Product Change Notification / LIAL-04DQNT801

eSign# E000173629 Final notice: Released of updated Libero SoC v2022.3 for selected products in the PolarFire FPGA device family, including MPFxxx and RTPF device families.

Subject: PolarFire® FPGA and SoC PORDIGEST and Tamper IP Update

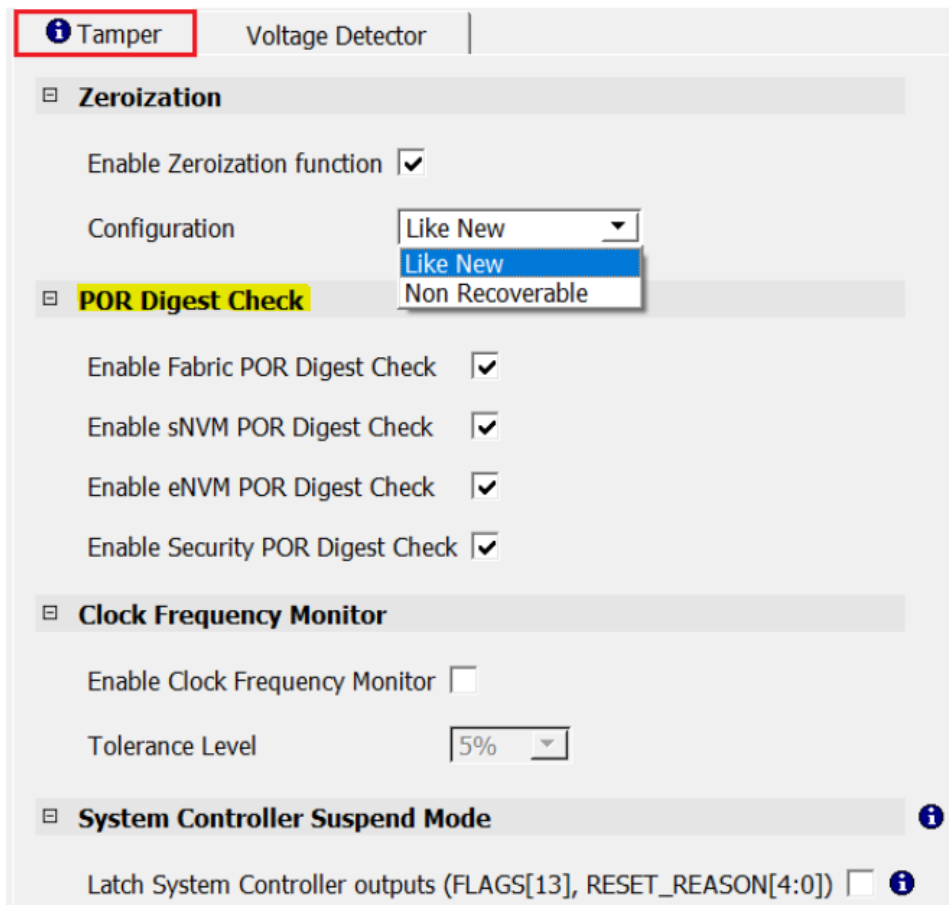
Designs using bitstreams generated prior to Libero SoC v2022.3, where the Tamper IP core is instantiated and configured to enable Power-On Reset digest checks on device components that were **not** included in the

programming bitstream, will see the Power-On Reset digest check fail. The Power-On Reset digest check failure causes the assertion of the corresponding Tamper IP core flag output. Although this Power-On Reset digest check failure is a false failure, the user design response to the tamper flag assertion determines the impact to the application.

The figure below shows the Tamper IP core configured with the Power-On Reset Digest Check enabled for all device components:

Important: **Enable eNVM POR Digest Check** is only applicable for the PolarFire SoC FPGA.

Upgrade to Libero SoC v2022.3, or later. Upgrade to the latest PF_TAMPER (v1.0.212 or later) or PFSOC_TAMPER (v2.0.100 or later) IP core, if used in the design. Then re-run the design flow, including the programming file generation and exports steps: Generate Bitstream, Export Bitstream, Export FlashPro Express Job and Export Job Manager Data.
